UNITED STATES PATENT AND TRADEMARK OFFICE

APPLICATION NO.	FILING DATE	FIRST NAMED INVENTOR	ATTORNEY DOCKET NO.	CONFIRMATION NO.
09/751,185	12/29/2000	Larry R. Fairbanks	CPS1540-203B	8520

Office Action Summary

DETAILED ACTION

FIG - 2

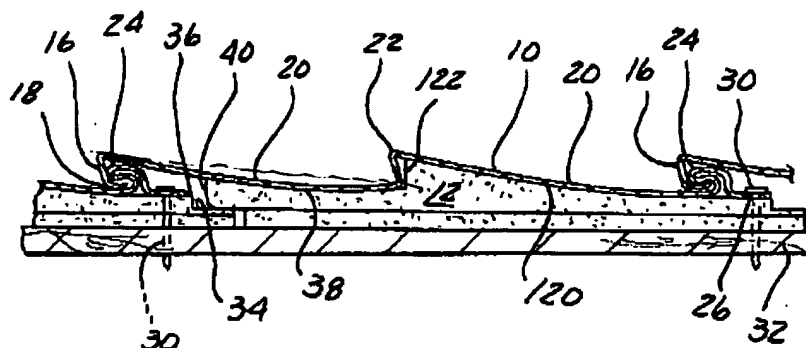
Culpepper et al. is considered to show and disclose, a vinyl siding panel comprising a facing panel (10) having at least two elongated planar portions (20) being edge-by-edge connected by a seam with a height to define a stepped contour (16) between the adjacent planar surfaces, each elongated planar portion (20) having a width extending between a first edge (22) and a second edge (16) of the planar portion, wherein each elongated planar portion (20) has a thickness about 0.035 inches (see col. 3, lines 48 or claim 16) and a width about 6 inches (or 12 inches of two planar portions) (see col. 8, line 31 or claim 17) which is in the range of "at least about 4 or 6 inches" as claimed. Culpepper et al. shows and discloses each elongated planar

portion (20) having a substantially "slight concave face" (col. 1, line 33) (see figures show bellow) formed between the first (22) and second (16) edges of the planar portions (20) for reducing or eliminating the occurrence of oil canning as the claimed invention, wherein the slight concave surface (20), in an other word, inherently has "a slight curvature" including a suitable dimension of a radius curvature, and the "slight concave surface" may include a suitable surface variance defined from the outer surface of the planar portion to an imaginary straight line (d) connected between the first (22) and second (16) edges of the planar portion due to the flexibility of the vinyl portion and the rough surface of the material. Although Culpepper et al. do not define the slight concave planar surface (20) of the siding panel having a specific surface variance as claimed, Culpepper et al. discloses the vinyl siding having the planar portion having a thickness about 0.035 inches and a width about 6 inches substantially within the range of dimension as claimed. And, Szabo teaches a method of forming a vinyl siding comprising a forming fixture having passage to form a siding panel with a plurality of substantially planar portions each having a thickness of about 0.042 inch and a surface clearance (or surface variance) of from 0.05 to 0.075 within a range of about 0.05 includes as claimed (see col. 5. lines 1-6; lines 67-79 to col. 6, lines 1-10). Therefore, it would have been one of ordinary skill in the art, at the time the invention was made to modify a sliding panel of Culpepper et al. having the substantially planar portions being performed equally well with a slide concave surface having vary widths such as 4 or 6 inches as claimed and having a thickness to define a suitable radius curvature and having a surface variance of less than about 0.05 inches as taught by Szabo as obvious matter of engineering design choice to define the specific dimensions to achieve the same function of providing the siding panel with very desirable random shadow pattern to add

Regarding claims 14 and 34-36, although Culpepper et al. do not define the slight concave planar surface (20) of the siding panel having a specific radius curvature as claimed, Culpepper et al. discloses the planar portion (20) of the vinyl siding having a thickness about 0.035 inches and a width about 6 inches substantially within the range of dimension as claimed. Therefore, it would have been obvious to one having ordinary skill in the art at the time the invention was made to modify the vinyl siding panel of Culpepper having the slide curved planar surface having very specific widths at least about 4 inches to define a corresponding specific radius curvature at least about 85 inches as claimed because of the change of the size of the panel portion merely involve of changing of the dimension of the radius curvature, and changing dimension for accommodating different applications when using an invention, having the same general structure would likely find different sizes or optimal dimensions of that structure with desirable appearance, and any such distinction would have been obvious as within the ordinary skill in the art. *See In re Pistilli*, 474 F. 2d 1024, 1026, 177 USPQ 262, 264 (CCPA 1973).

Regarding claims 9, 12, 22, and 25, although Culpepper et al. does not define the stepped contour of the seam between two adjacent planar surfaces of the siding panel having a specific height at least about 0.5 inches as claimed, it would have been obvious to one having ordinary skill in the art at the time the invention was made to modify the vinyl siding panel of Culpepper having the stepped contour of seam with a specific height of at least about 0.5 inches as claimed. since the applicant has not disclosed that the specific dimension of the height of the seam solves any stated problem or is for any particular purpose and it appears that the claimed invention would perform equally well with the stepped contour of the seam between two planar surfaces constructed with a specific height of about 0.5 inches to achieve the desirable result of siding panel of variety applications. And, for accommodating different applications when using an invention, having the same general structure would likely find different sizes or optimal dimensions of that structure with desirable appearance, and any such distinction would have been obvious as within the ordinary skill in the art. *See In re Pistilli*, 474 F. 2d 1024, 1026, 177 USPQ 262, 264 (CCPA 1973).

Figure 4

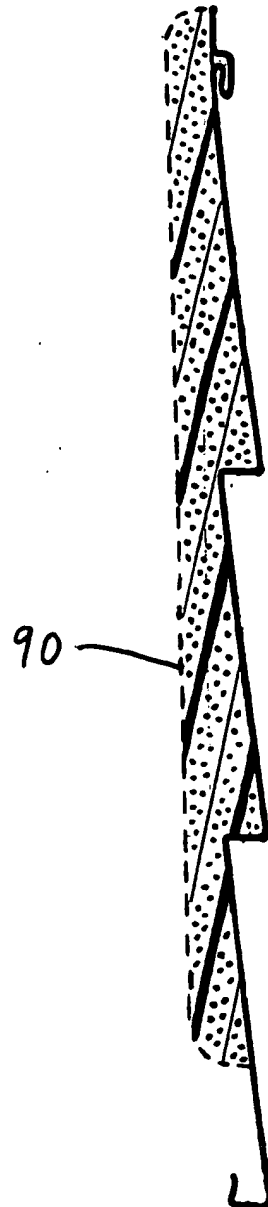
1. The disclosure is objected to because of the following informalities: the new Figure 4 (filed September 10, 2004) has not been described in the specification under sections of "Brief Description Of The Drawings" and "Detailed Description Of Exemplary Embodiment".

Appropriate correction is required.
